THE CITY OF DURHAM TRUST

8 June 2023

DM/22/03778/FPA: Hybrid planning application consisting of outline planning permission (all matters reserved) for an extension to the Sniperley Park and Ride, and full planning permission for the development of 368 dwellings, associated access and works, and demolition of former farm buildings (resubmission).

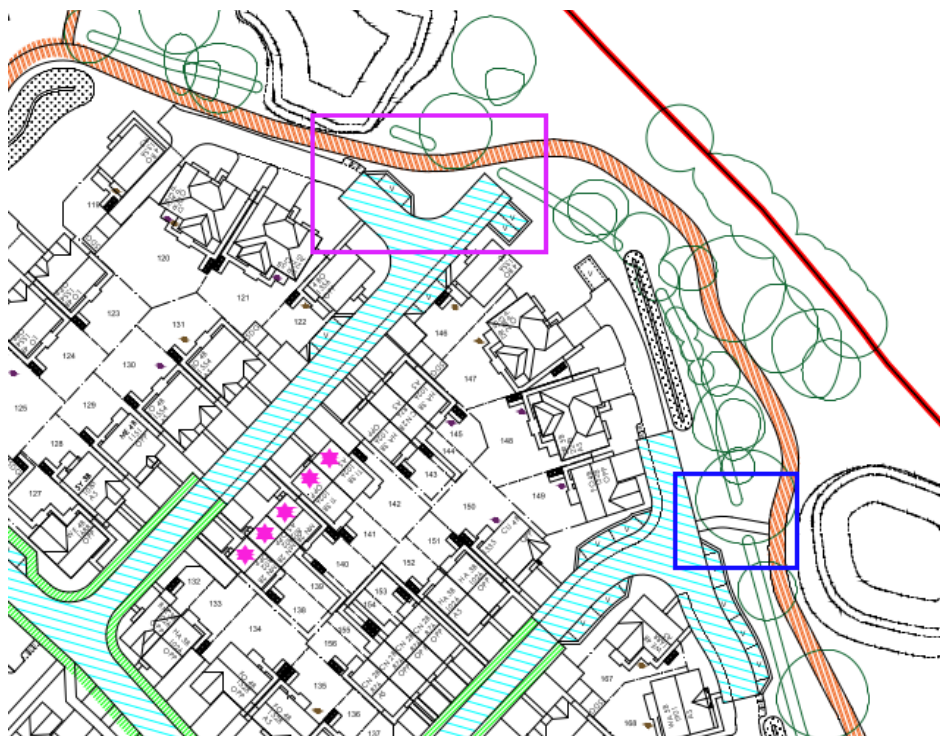
- Page 55 of the revised Design and Access Statement seems to be consistent with the covering letter, showing a cycle connections at the

northern end of the site, through the green space surrounding the power lines, and north-east from Sniperley Hall. A connection heading east, just north of the proposed link road, is shown as pedestrian only, whereas in the previous iteration of the Design and Access Statement this was shown as a cycle route (though it is probable that that version was mislabelled).

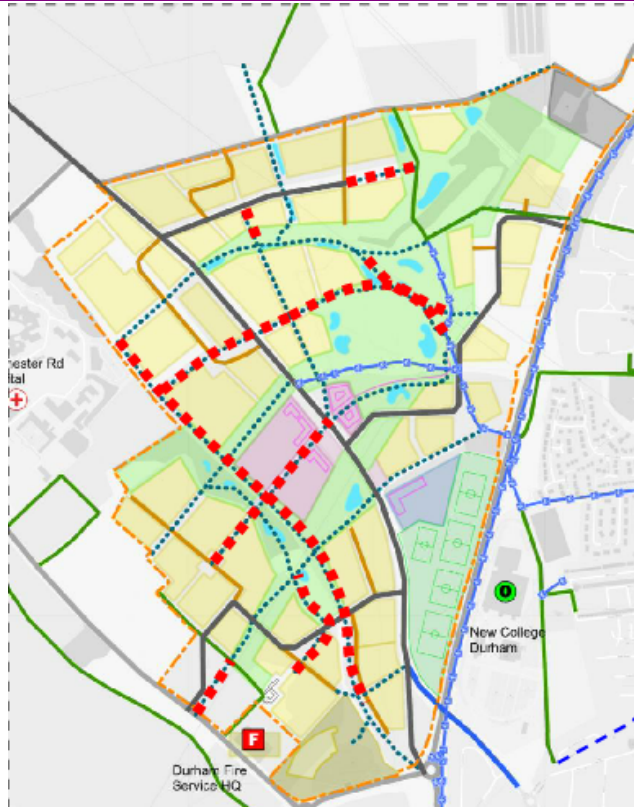
Two of the cul-de-sacs in the northern end of the site do not have adoptable connections onto the adjacent path.

In the area outlined in blue, there appears to be a path connection, but it has not been coloured as adoptable, in contrast to connections from other streets.

In the area outlined in purple, however, there is no path connection. The Trust would like to see this remedied, and if a revised Adoptable Highways Plan is required in order to deal with the inconsistencies, this amendment could be requested at the same time. Otherwise it should be secured via a condition.
